**Re: JD-9 Mine Drainage Design Plan – Second General Stormwater Comments,
Permit No. M-1977-306 / AM-01**

The Division of Reclamation, Mining and Safety (DRMS) engineering staff has reviewed the August 1, 2013 "Response to General Stormwater Comments, dated February 22, 2013 for the JD-9 Mine prepared by O'Connor Design Group, Inc. The following comments are posed to ensure adequate engineering analyses and design practices are implemented to eliminate or reduce to the extent practical the disturbance to the hydrologic balance expected by the mining operation with respect to water quality and quantity in accordance with Rules 3.1.6(1), 6.4.21(10) and 7.3.1. Please note, as this site is a designated mining operation (DMO), compliance with Rule 7.3.1 is applicable, thus requiring certified designs and specifications for engineered elements associated with the environmental protection plan (EPP). The original comment numbers have been retained for the purpose of tracking responses.

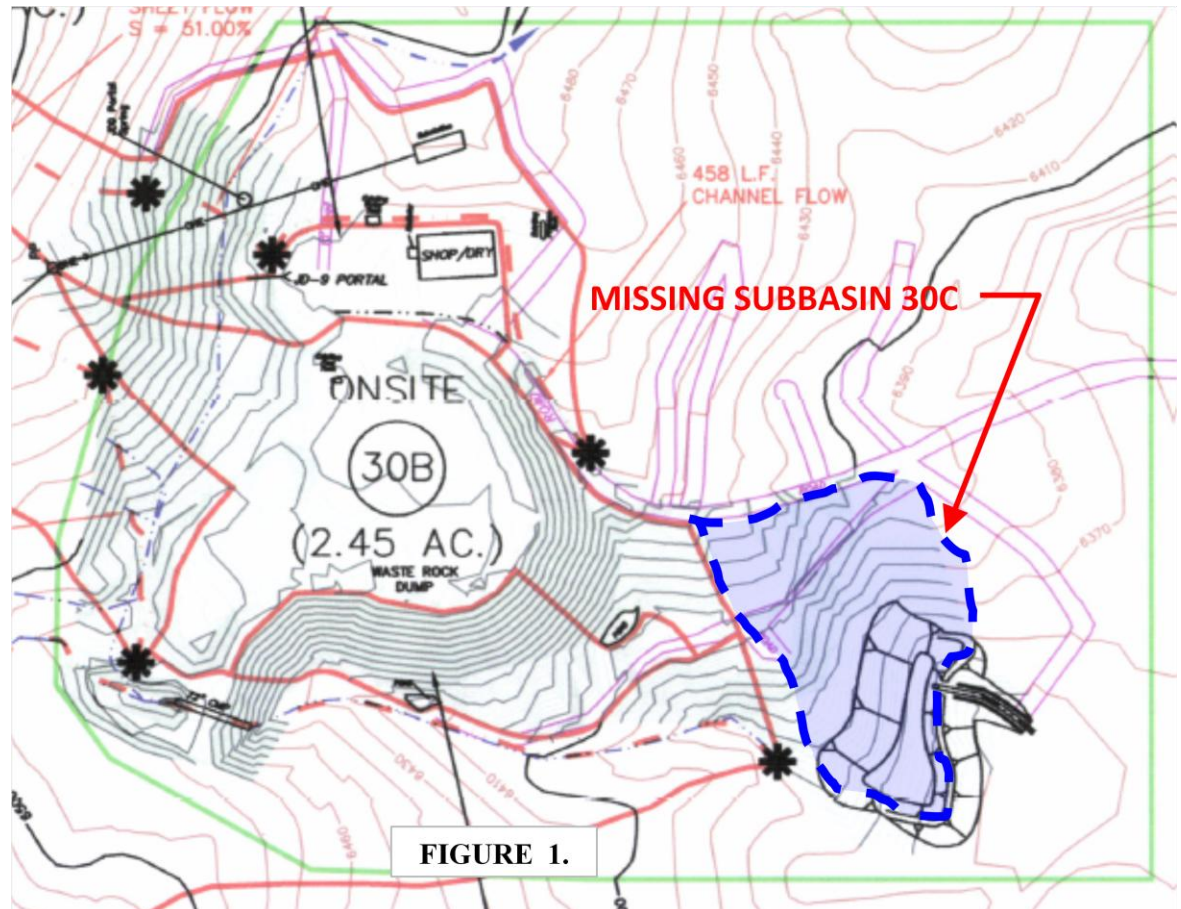
- a. The missing subbasin (labeled 30C) contributing to the proposed retention pond 30, see Figure 1 below must be added to account for runoff from this area to the pond. Adjustments will need to be made to spillway and chute design analyses.

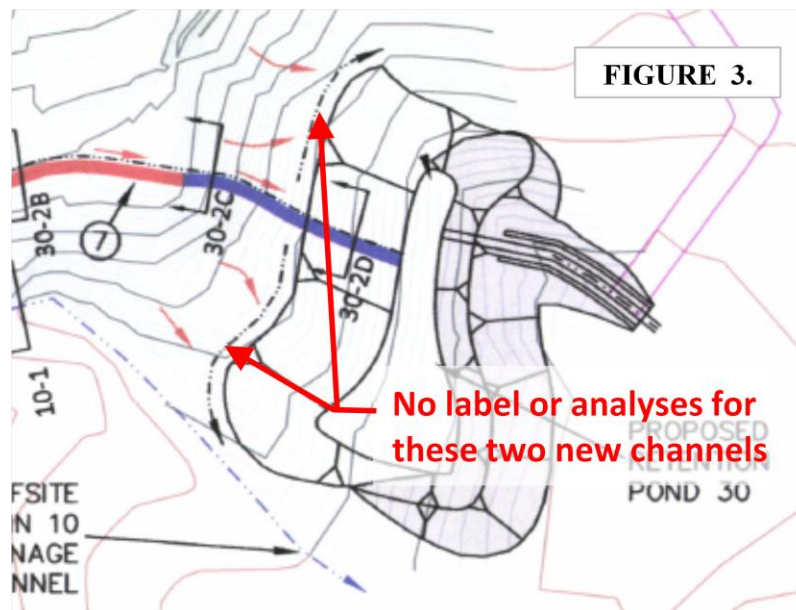
- a. There are two diversion channels upgradient of proposed retention pond that have not labeled or analyzed. Please see Figure 3 below and either provide the requisite analyses or remove them from Sheet 3 of 10.

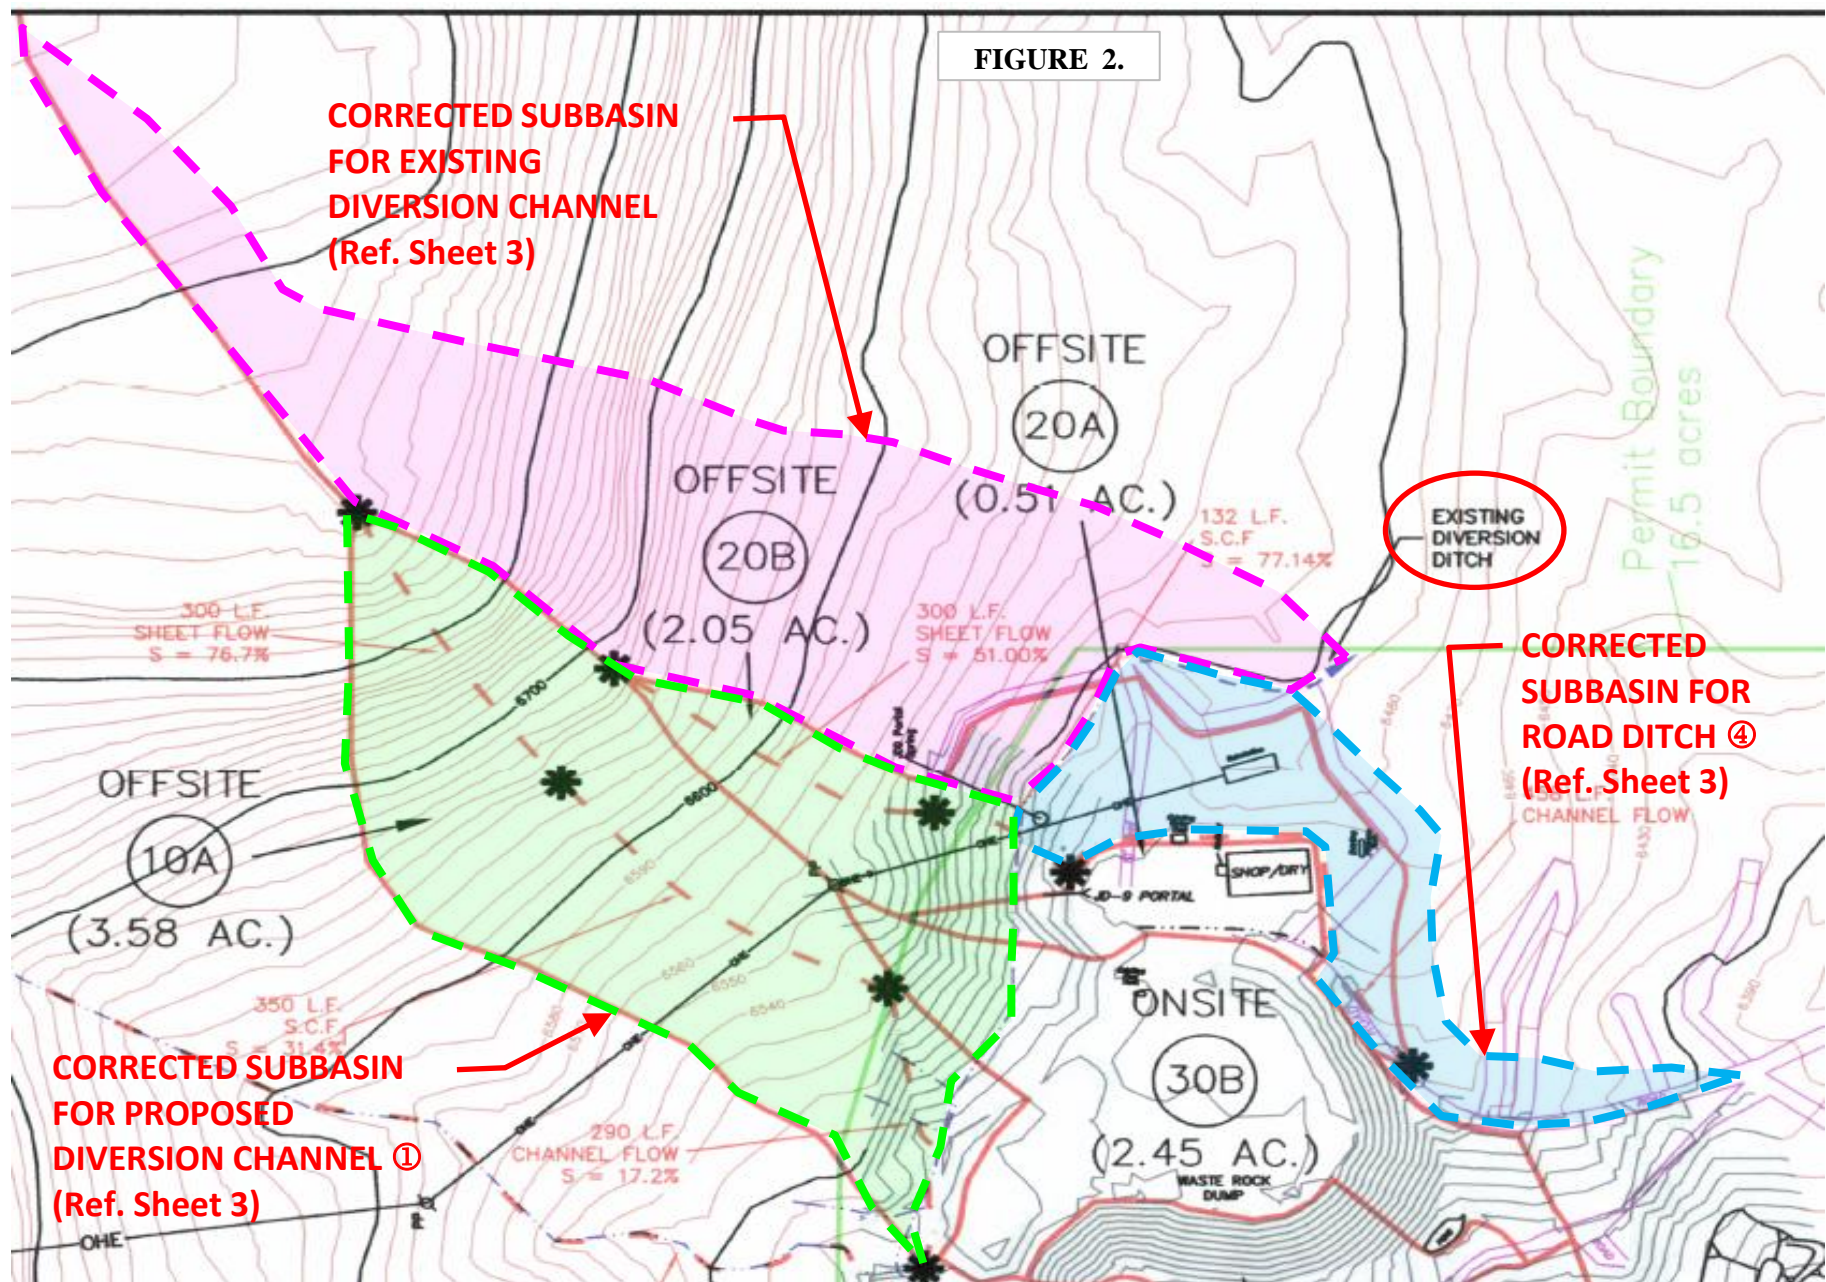
- b. The subbasin area contributing to the existing road ditch ④ (ref. Sheet 3 label) has been reduced. Please reference Figure 2 (attached) to see the area (highlighted in light blue) DRMS deems necessary to address contributing runoff to existing road ditch ④ and ensure adequate design capacity and stability. Please revise the hydrology estimates and make the necessary adjustments to the channel analyses for capacity and stability. Section 20-1 may need a flatter slope to be considered for the capacity analysis. (Note this area was included in the 9/12/2012 submittal).

- c. The new “existing” diversion ditch east of Offsite 20B is not analyzed for stability or capacity nor is the contributing subbasin drawn to consider it. Please reference Figure 2 (attached) to see the area (highlighted in magenta) DRMS deems necessary to address contributing runoff to this existing diversion ditch and ensure adequate design capacity and stability. Please revise the hydrology estimates and make the necessary adjustments to the channel analyses for capacity and stability.

- d. Subbasin 10A is not drawn to consider the proposed diversion channel ① (ref. Sheet 3 label). Please reference Figure 2 (attached) to see the area (highlighted in

green) DRMS deems necessary to address contributing runoff to this existing diversion ditch and ensure adequate design capacity and stability.
